SPECIAL LETTER 16-13

SUBJECT: To ADVISE MOONEY OWNERS/OPERATORS of the **LYCOMING SERVICE INSTRUCTION NO. 1514C (Supersedes Service Instruction No. 1514B) - Issued 10/13/2016 - Roller Tappets Part Information Update (see Attached).**

Service Instruction No. 1514C
(Supersedes Service Instruction No. 1514B)
Engineering Aspects are
FAA Approved

SUBJECT: Roller Tappets Part Information Update

Figure 1
Roller Tappet Assemblies

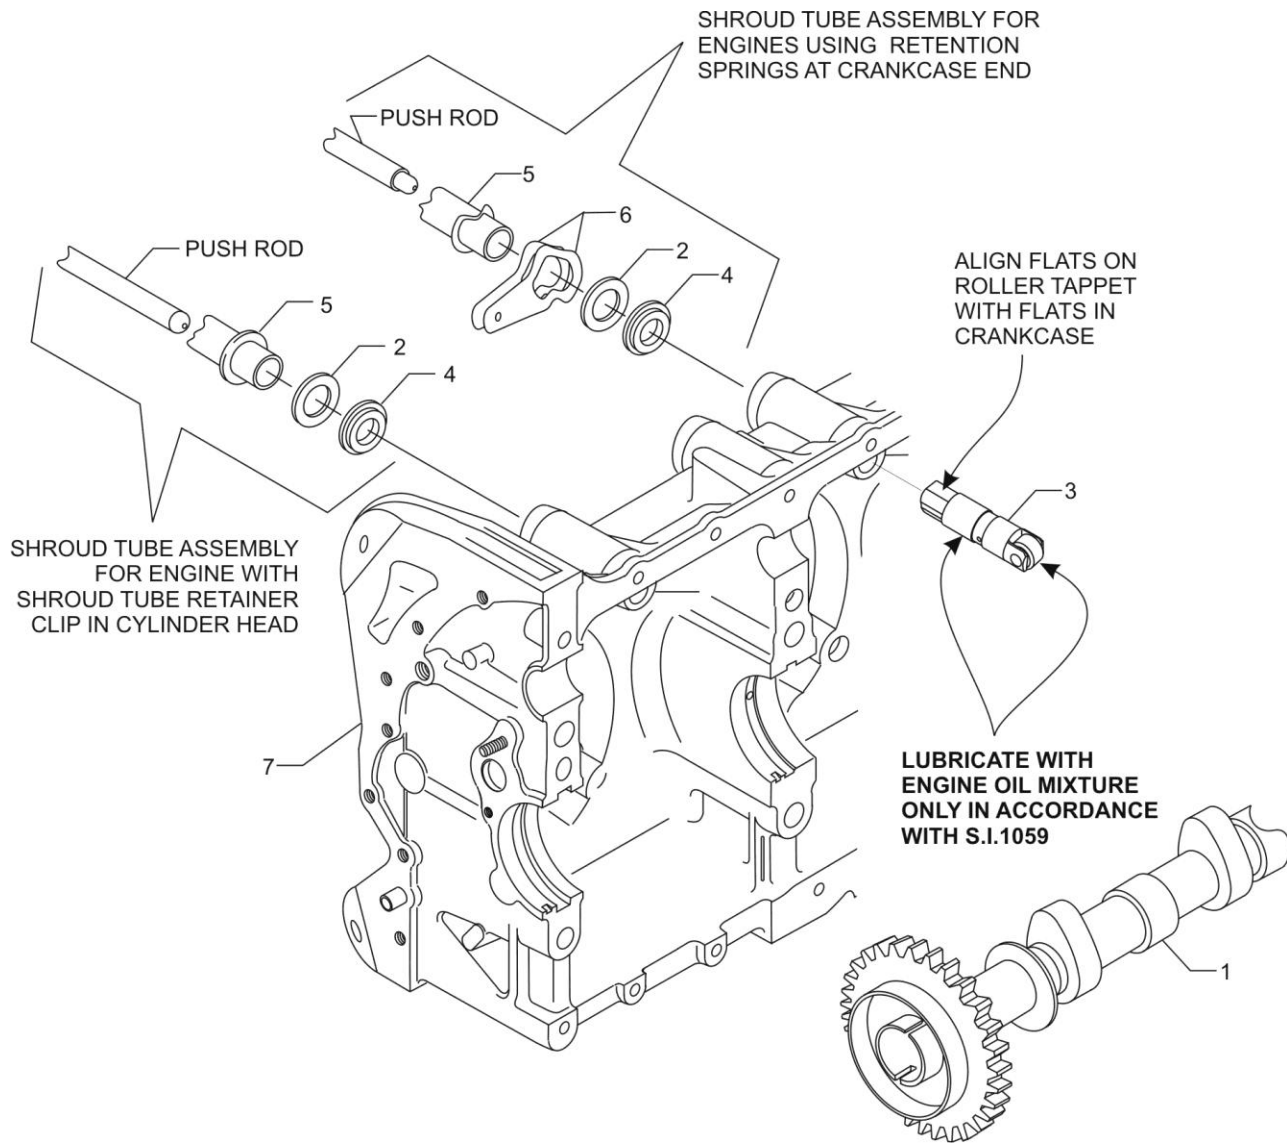
WARNING: ROLLER TAPPET PARTS ARE NOT INTERCHANGEABLE WITH CURRENT FLAT FACED TAPPETS.

If it is necessary to remove the roller tappet bodies prior to overhaul, they **must be reinstalled in the same location in the crankcase.** The roller tappets are indexed with flats in the new crankcase. It is possible to assemble the roller tappet bodies in two different orientations 180 degrees apart. Either orientation is acceptable while reinstalling. Lubricate all tappet bores, cam lobes and roller tappets with engine oil mixture only. (Refer to the latest revision of Service Instruction No. 1059.) Install the shroud tube seal in the crankcase, then install the shroud tube.

Following is a list of the parts, roller tappet part numbers and flat tappet part numbers for four-cylinder aircraft engines. (Refer to illustration.)

Following is a list of the parts, roller tappet part numbers and flat tappet part numbers for six-cylinder aircraft engines. (Refer to illustration.)

Item No.	Current Flat Tappet P/N	New Superseding Roller Tappet P/N	Description
1	LW-18840	15M23452	Camshaft Assy.
1	LW-18845	15M23454	Camshaft Assy. (Left-Hand Engine Rotation)
1	LW-18843	15M23456	Camshaft Assy.
1	15M19407	15M23496	Camshaft Assy. (Left-Hand Engine Rotation)
2	66728	01L23459	Washer, .78 ID x 1-3/8 OD x .041
3	72877	LRT23381	Body Assy., Hydraulic Tappet Roller
4	LW-18661	06A23493	Seal, Shroud Tube
5	LW-11485	15G23461	Shroud Tube
5	72255	15G23462	Shroud Tube
5	68987	15G23494	Shroud Tube
6	LW-13077	15H21201	Spring, Shroud Tube
7	LW-13823-1	LW-13823-5	Crankcase Assy.
7	LW-18399-1	LW-18399-5	Crankcase Assy.
7	LW-18402-2	LW-18402-5	Crankcase Assy.
7	LW-18770-1	LW-18770-5	Crankcase Assy.
7	11B19524-1	11B19524-5	Crankcase Assy.
7	11B20061-1SL	11B20161-1SL	Crankcase Assy.
7	11B20061-1SH	11B20161-1SH	Crankcase Assy.
7	11B20061-1SB	11B20161-1SB	Crankcase Assy.
7	11B20061-1DL	11B20161-1DL	Crankcase Assy.

Item No.	Current Flat Tappet P/N	New Superseding Roller Tappet P/N	Description
1	LW-19340	15N23374	Camshaft Assy.
1	-----	15N26092	Camshaft - No Tach Shaft (Roller Lifter)
2	66728	01L23459	Washer, .78 ID x 1-3/8 OD x .041
3	72877	LRT23381	Body Assy., Hydraulic Tappet Roller
4	LW-18661	06A23493	Seal, Shroud Tube
5	LW-11485	15G23461	Shroud Tube
5	LW-18944	15G23487	Shroud Tube
5	72255	15G23462	Shroud Tube
5	72257	15G23948	Shroud Tube
6	LW-13077	15H21201	Spring, Shroud Tube
7	11E24000-D1	11E24100-D1	Crankcase Assy.
7	11E24000-D2	11E24100-D2	Crankcase Assy.
7	11E24000-S1	11E24100-S1	Crankcase Assy.
7	11E24000-S3	11E24100-S3	Crankcase Assy.
7	11E24000-S4	11E24100-S4	Crankcase Assy.
7	11E24001-S1	11E24101-S1	Crankcase Assy.
7	11E24001-S4	11E24101-S4	Crankcase Assy.
7	11E24002-D3	11E24102-D3	Crankcase Assy.
7	11E24005-S1	11E24105-S1	Crankcase Assy.
7	-----	11E24106-S1 ▲	Crankcase Assy.
7	11F24020-D1	11F24120-D1	Crankcase Assy.
